# CERTIFICATE OF APPROPRIATENESS

**HPO File#:** HP2026\_0016

**REVISION to HP2024\_0317 02/27/2025**

**Proposal:** Alteration -  
Restore All Windows at 505 and Replace Shutters  
Replace All Windows at 503

PROPOSED 503 SUL ROSS

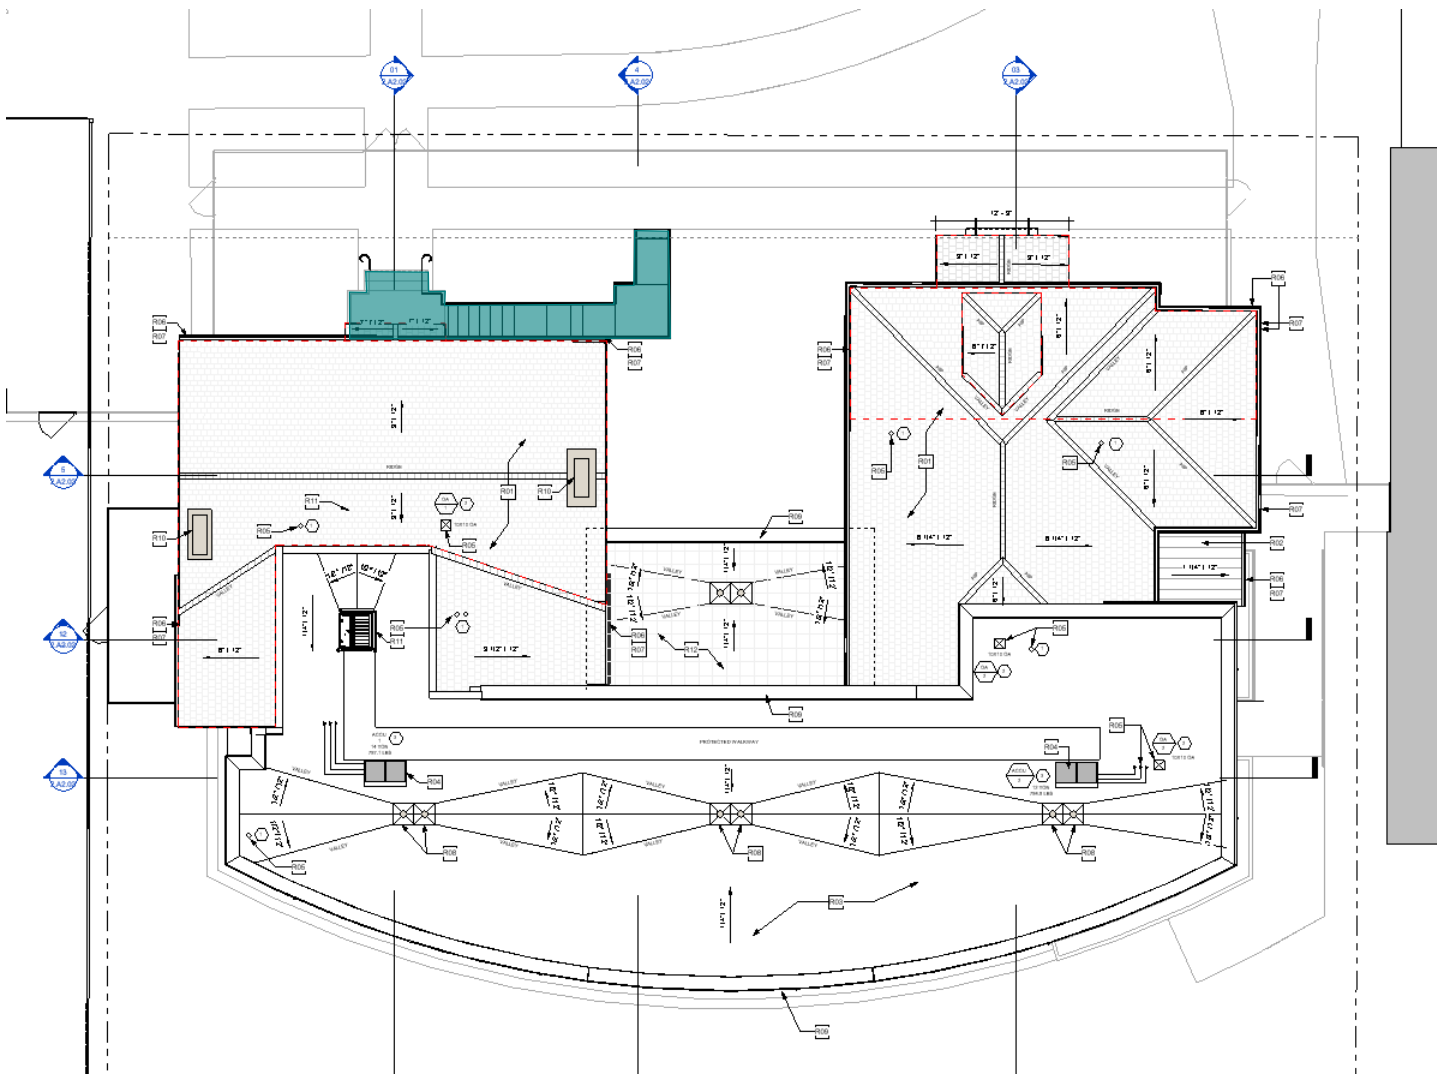
We are proposing to remove all existing stucco from 503 and replace with new stucco. The stucco texture will be applied in a wet-pebble-dash manner by hand. A sample of the stucco will be provided to the Historic reviewer during construction. We are also proposing to remove the non-historic band around the lower portion of the facade. All other historic stucco detailing will be reapplied during construction.

The City of Houston Structural department has requested the installation of a handrail outside the front entry of 503. We intend to use simple steel handrails, painted black similar to 505 Sul Ross.

503 Sul Ross St. - applicant must submit sample of dash finished stucco for staff approval before proceeding.

PROPOSED PLAN - RAMP ADDITION

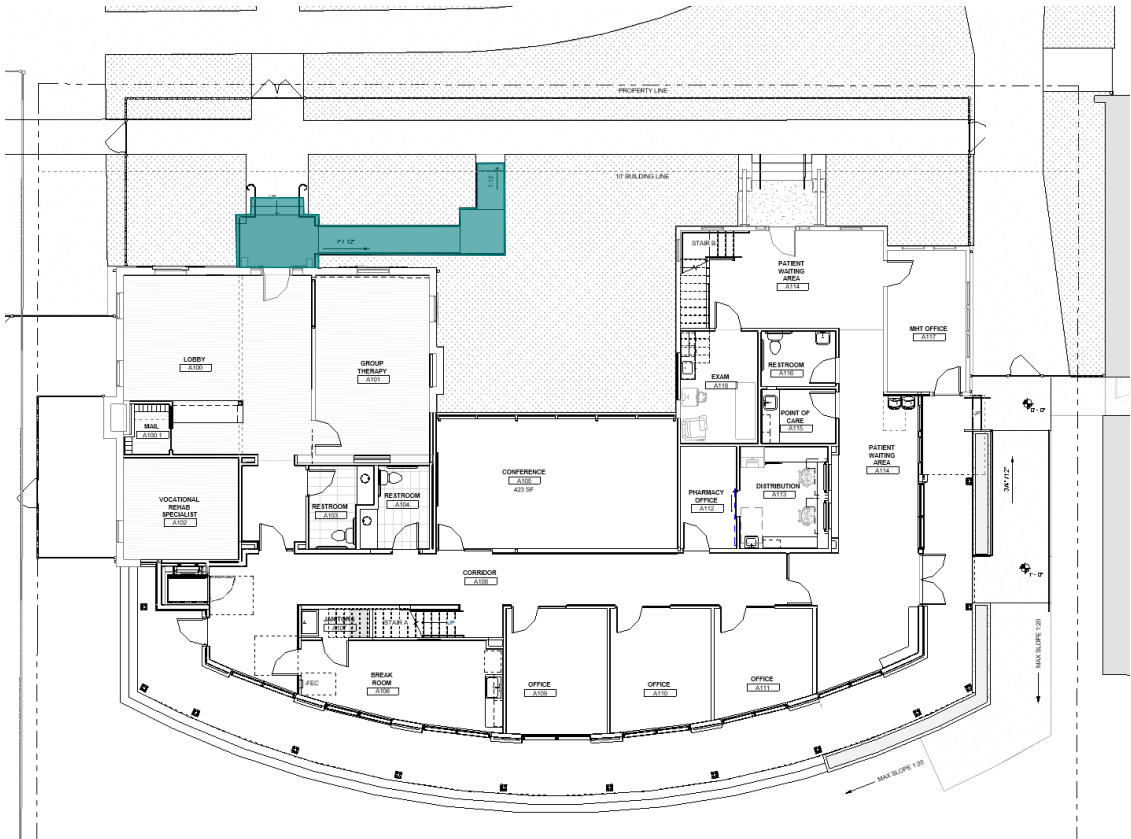
- Install ADA compliant metal ramp with wrought iron handrails. Proposed ramp laid out from front brick landing East close to facade.

505 SUL ROSS - SIDE (EAST ELEVATION)

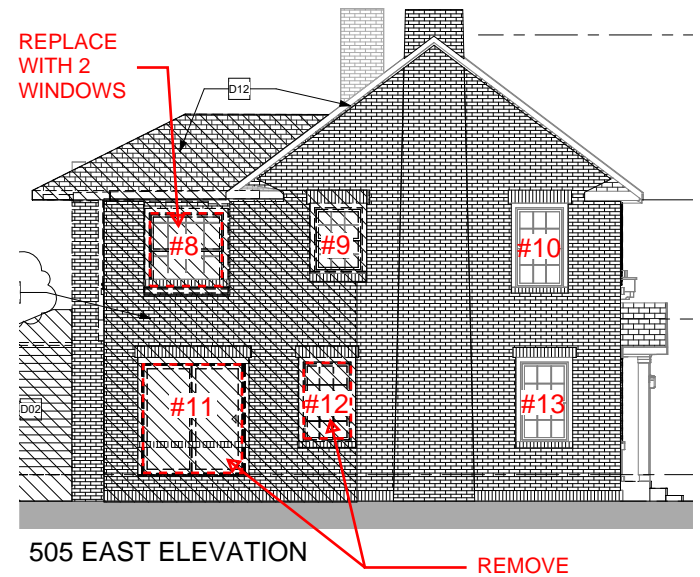
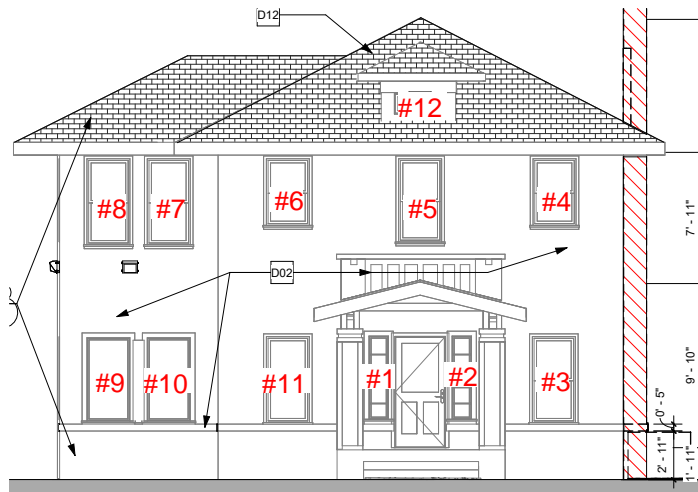
**SIDE (EAST ELEVATION) #8**  
TO BE REPLACED WITH 2 NEW WINDOWS, NOT ORIGINAL

**SIDE (EAST ELEVATION) #11**  
TO BE REMOVED, NOT ORIGINAL

**SIDE (EAST ELEVATION) #12**  
TO BE REMOVED, REFER TO ORIGINAL COA APPLICATION, CONFLICT WITH WALL

503 SUL ROSS - FRONT (NORTH ELEVATION)

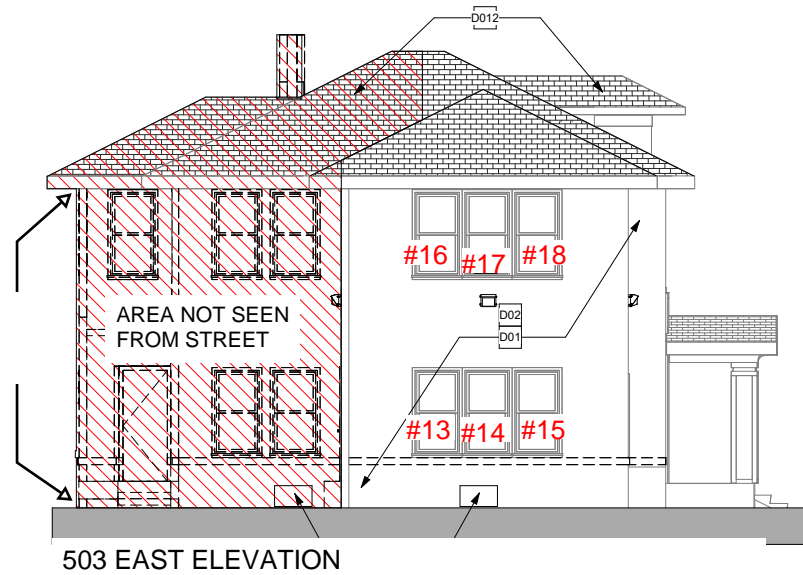
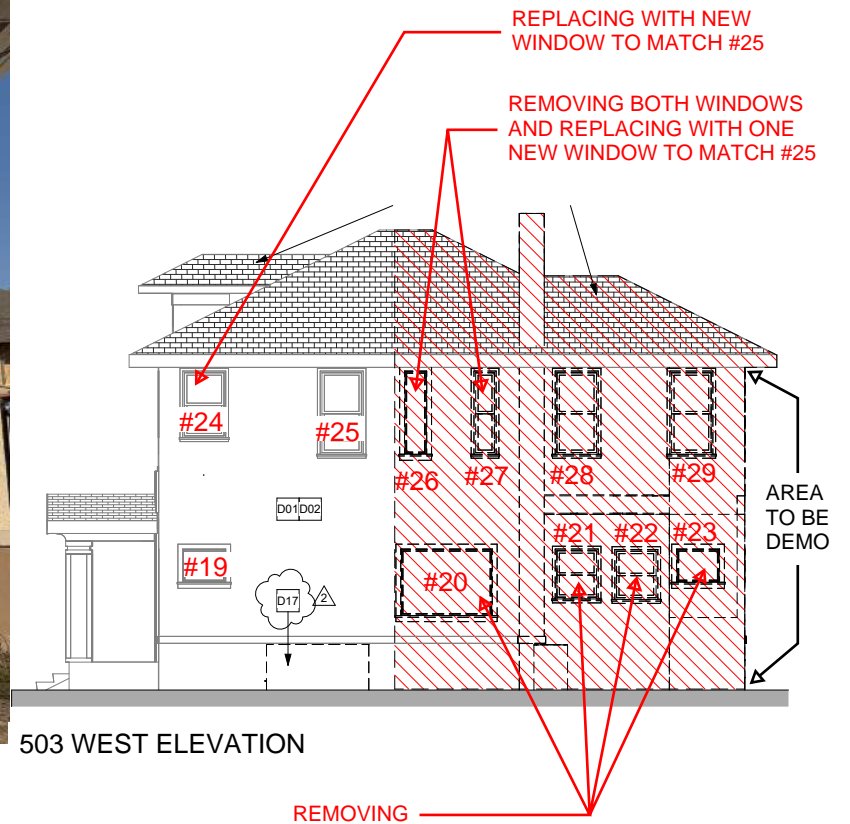
**FRONT (NORTH ELEVATION) #1 AND #2**  
TO BE REPLACED WITH NEW TO MATCH EXISTING

**FRONT (NORTH ELEVATION) #3**  
TO BE REPLACED WITH NEW TO MATCH EXISTING

**FRONT (NORTH ELEVATION) #4**  
TO BE REPLACED WITH NEW TO MATCH EXISTING

**FRONT (NORTH ELEVATION) #6**  
TO BE REPLACED WITH NEW TO MATCH EXISTING

**FRONT (NORTH ELEVATION) #5**  
TO BE REPLACED WITH NEW TO MATCH EXISTING

**FRONT (NORTH ELEVATION) #7 AND #8**  
TO BE REPLACED WITH NEW TO MATCH EXISTING

**FRONT (NORTH ELEVATION) #9 AND #10**  
TO BE REPLACED WITH NEW TO MATCH EXISTING

**FRONT (NORTH ELEVATION) #11**  
TO BE REPLACED WITH NEW TO MATCH EXISTING

**FRONT (NORTH ELEVATION) #12**  
TO BE REPLACED WITH NEW TO MATCH EXISTING

**SIDE (EAST ELEVATION) #13, #14, AND #15**  
TO BE REPLACED WITH NEW TO MATCH EXISTING, ALL 3 NOT ORIGINAL

**SIDE (EAST ELEVATION) #16, #17, AND #18**  
TO BE REPLACED WITH NEW TO MATCH EXISTING, ALL 3 NOT ORIGINAL

**SIDE (WEST ELEVATION) #19**  
TO BE REPLACED WITH NEW TO MATCH EXISTING

**SIDE (WEST ELEVATION) #20**  
TO BE REMOVED

**SIDE (WEST ELEVATION) #21, #22, AND #23**  
TO BE REMOVED

**SIDE (WEST ELEVATION) #24**  
TO BE REPLACED WITH NEW TO MATCH #25

**SIDE (WEST ELEVATION) #25**  
TO BE REPLACED WITH NEW TO MATCH EXISTING

**SIDE (WEST ELEVATION) #26 AND #27**

BOTH WINDOWS TO BE REMOVED, REPLACING WITH ONE NEW WINDOW TO MATCH #25

**SIDE (WEST ELEVATION) #28 AND #29**

TO BE REPLACED WITH NEW TO MATCH EXISTING, BOTH NOT ORIGINAL
